## ADDENDUM NO. 1

PROJECT: REGION 7 HEADQUARTERS STORAGE BUILDING

FWP PROJECT # 7199152 | SDI #1939

DATE: March 19, 2020

# 6B-Glu-Lam Beam

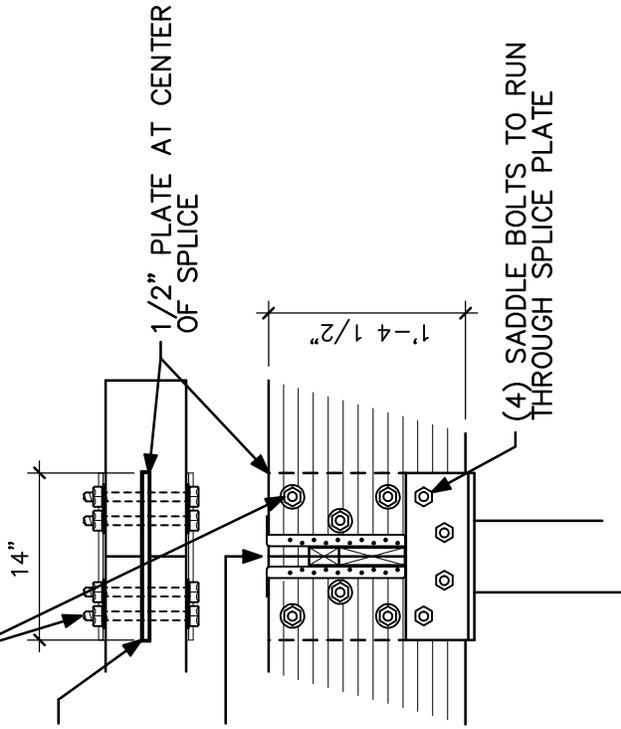
6 3/4" X 16 1/2" GLU-LAM BEAM  
BLDG. ENG. TO VERIFY SIZING

TRUSS HANGERS SUPPLIED BY TRUSS MFG.

(4) 3/4" A325 THROUGH BOLTS  
WITH FLAT WASHERS EACH SIDE  
THROUGH SADDLE AND BEAM

1/2" PLATE SADDLE BASE  
W/ 3/8" PLATE SIDES

# 6C-Glu-Lam End & Splice

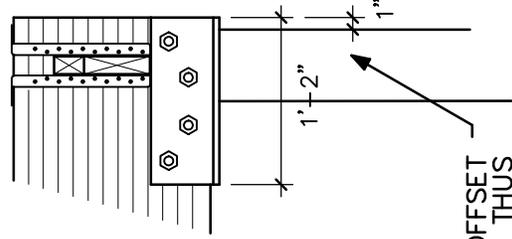
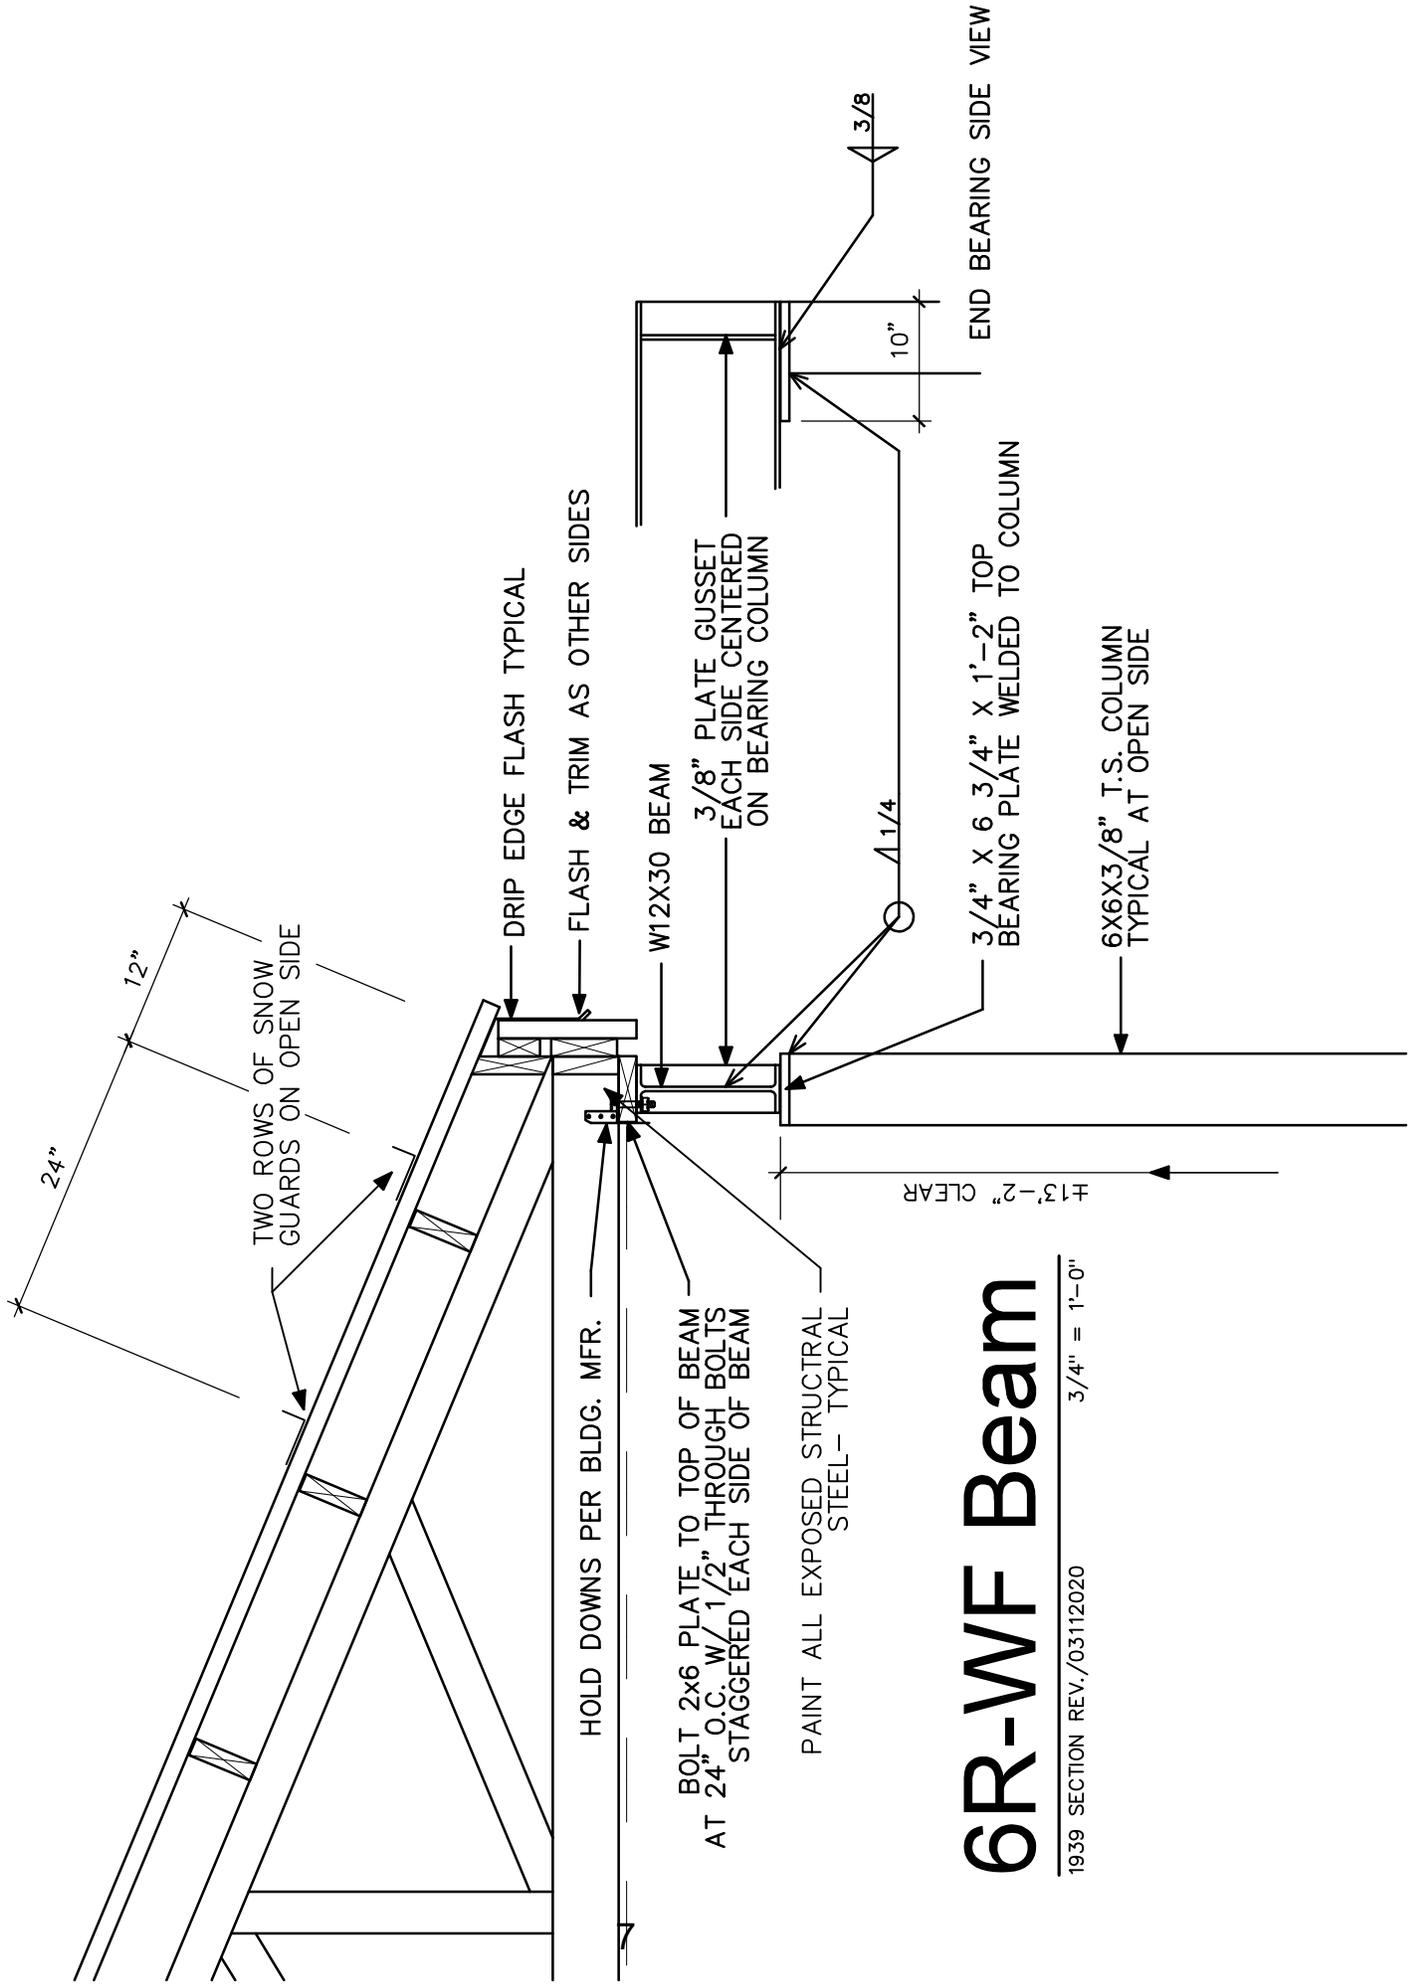
(6) 3/4" A325 THROUGH BOLTS WITH  
OVERSIZED WASHERS

CUT SLOT IN EACH END OF BEAM  
TO FIT TIGHT OVER SPLICE PLATE

SPLICE GL BEAM OVER  
CENTER OF SADDLE

(4) SADDLE BOLTS TO RUN  
THROUGH SPLICE PLATE

AT END COLUMNS OFFSET  
SADDLE THUS

# 7B-Column Base B&C

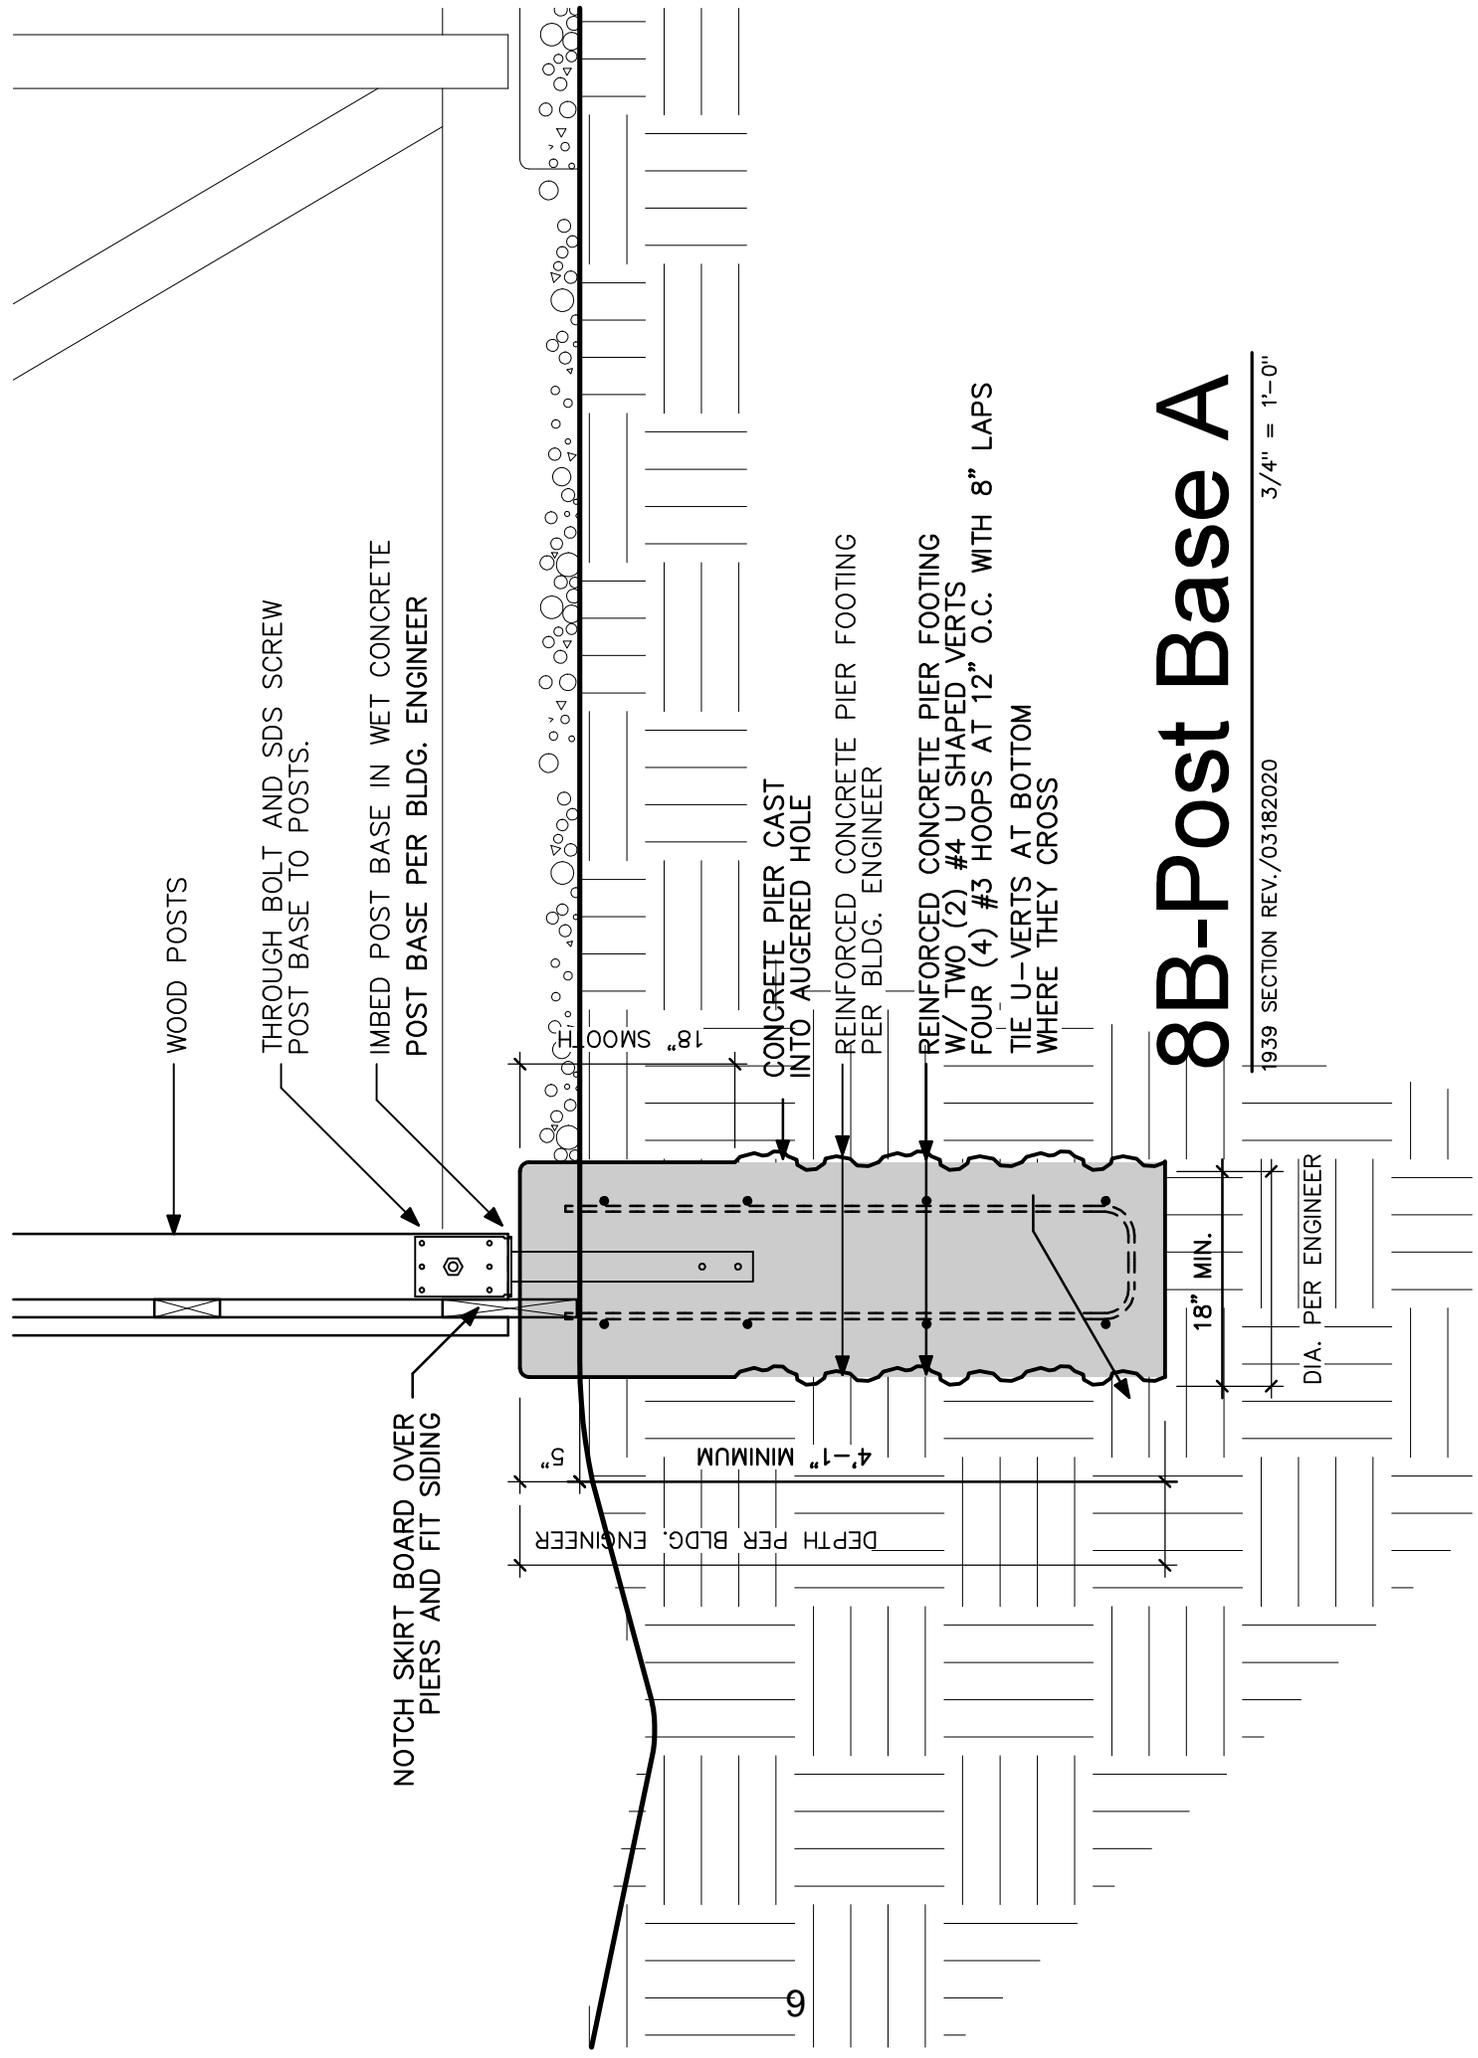
(4) 5/8" x 24" A.B.'s THROUGH  
3/4" x 1'-0" x 12" BASE PLATE

6X6X3/8" T.S. COLUMN  
TYPICAL AT OPEN SIDE

16"X16" SQUARE REINFORCED  
CONCRETE PIER

16"X16" SQUARE REINFORCED CONCRETE PIER  
W/ #6 x 16" x 48" J-BARS AND  
(5) #3 HOOPS AT 12" O.C. W/ 8" LAPS

48" X 48" X 12" REINFORCED CONCRETE FOOTING  
W/ #4 BARS AT 12" O.C. EACH WAY
